54–365 Disabling the ‘Park Brake Set / Door Open’ Warning and Changing the Part Number in the sSAM02T Module

TSB-54-365-FTL

- ▶ Business Class M2 Plus
- ▶ 108SD Plus
- ▶ 114SD Plus

Fig. 2, Updating the PASC_Alert_Hrn_Enabled Parameter Part Number

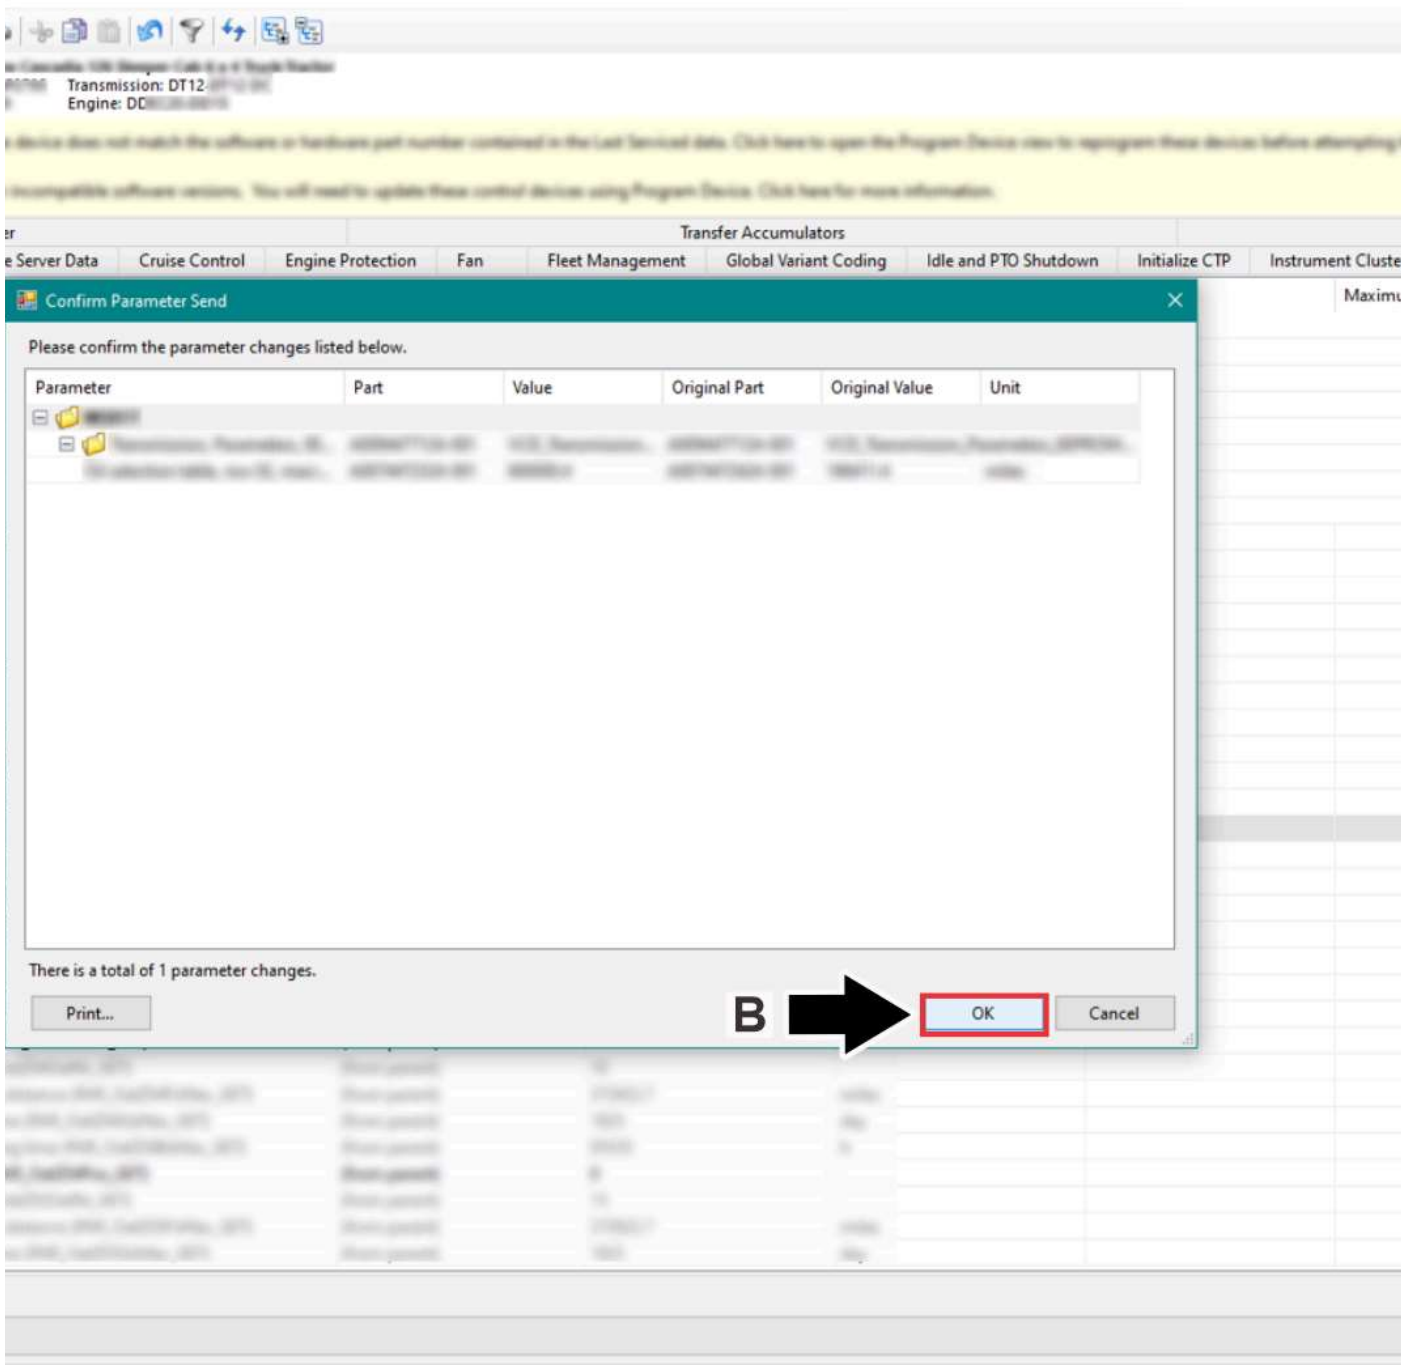
10. Select the 'PASC_Alert_Hrn_Enabled' parameter, and set the parameter value to 'A0214432858-001.' See Fig. 2. This disables the horn alert when the door is opened.

- A. Go to the 'Parameters' tab.
 B. Select and expand the 'SSAM02T - Single SAM' folder.
 C. Select and expand the 'ASC Horn Alert' sub-folder.
 D. Select the 'PASC_Alert_Hrn_Enabled' parameter.
 E. Set the parameter value to 'A0214432858-001.'

Fig. 5, Uploading the New Parameters

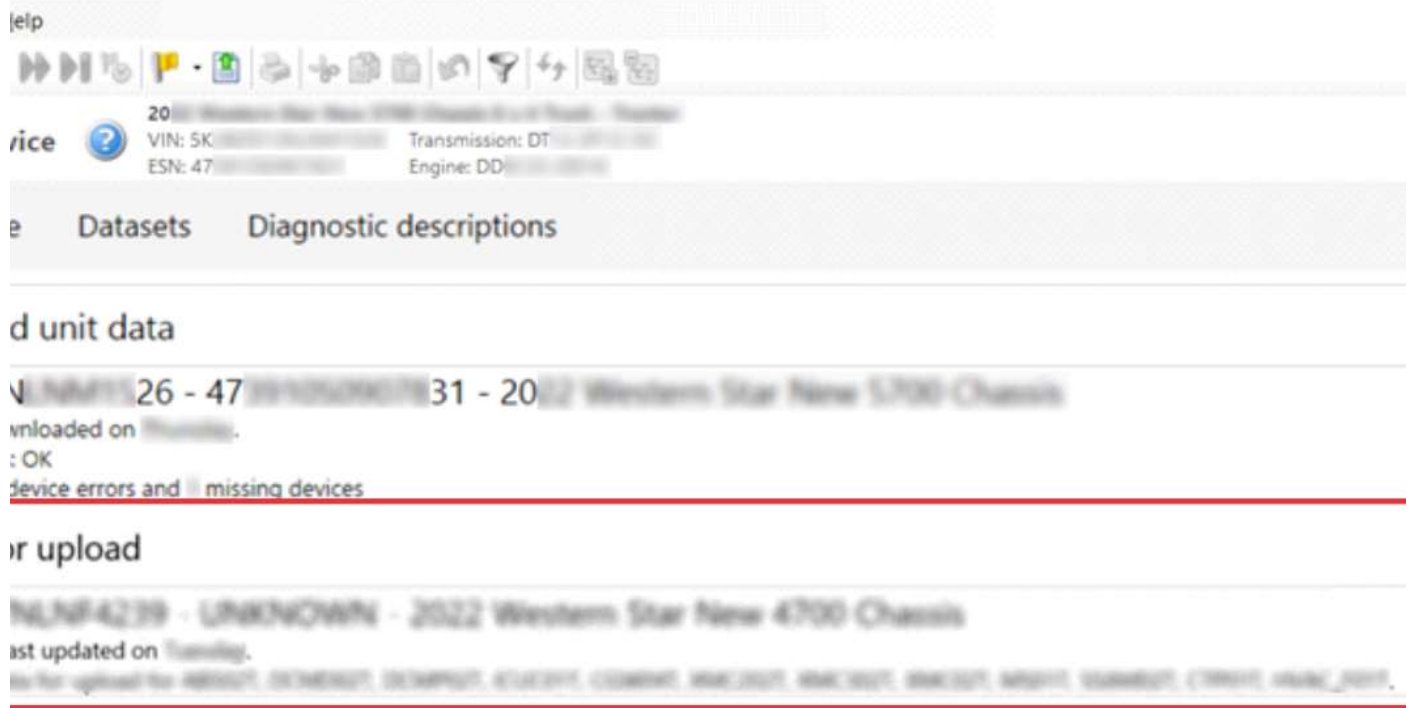
13. The information corresponding to the VIN should appear under the 'Unit data for upload.' Select 'Connect to server' to upload the new parameters. See Fig. .
